Muttum Lighthouse.

No. 33. NOTE BY THE CHIEF ENGINEER.

Proposed Lighthouse at Muttum. — Orders
issued for the speedy preparation of the
plans and estimates for the —.

Remarks regarding the
first class light and
lighthouse at Muthum

In the rough marginal plan—

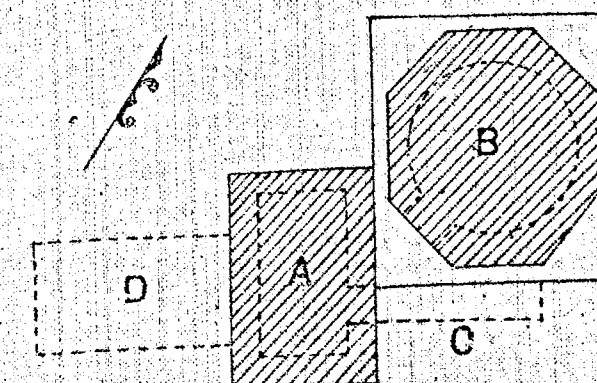
A is the existing tower with flat top on which the light is displayed, said to be 95 feet above mean sea level. The lower portion is used as an oil godown and the walls are about $2\frac{1}{2}$ feet thick.

B is the tower which I would

In the rough marginal
 plan

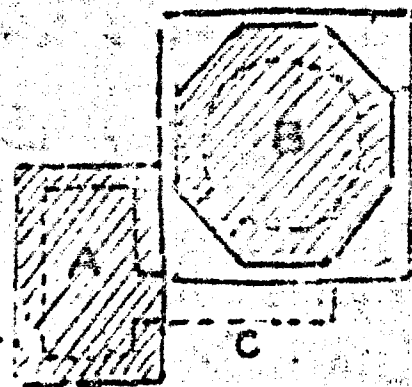
A is the existing tower
 with flat top on which
 the light is displayed
 said to be 95 feet
 above mean sea
 level. The lower
 portion is used as
 an oil storehouse &
 the walls are about
 2½ ft. thick.

B is the tower which
 I would propose to

build close along side
 square in base & turning
 above into a spiral
 or octagon with spiral
 stair case in the centre
 extend on from the
 present platform A at
 15 ft. from the ground.

As the diameter of the
 new light is believed to
 be 9 feet (the present
 dimensions will be from
 afterwards) the dimen-
 sions of the tower will
 be so arranged as to
 allow a clear passage
 at base of the light of
 not less than 2 feet all
 round to provide for
 the attendant, but here
 it may be assumed
 that at base the tower
 will not be more than
 15 feet square and the
 diameter of the tower
 above say 13 feet.
 The height of the base
 of the lantern would
 probably be 45 feet above
 the present ground.

Instead of the ladders
now used at C in the
plan I would substitute
a simple earthen ramp
with convenient slope
and rough stone steps
at D
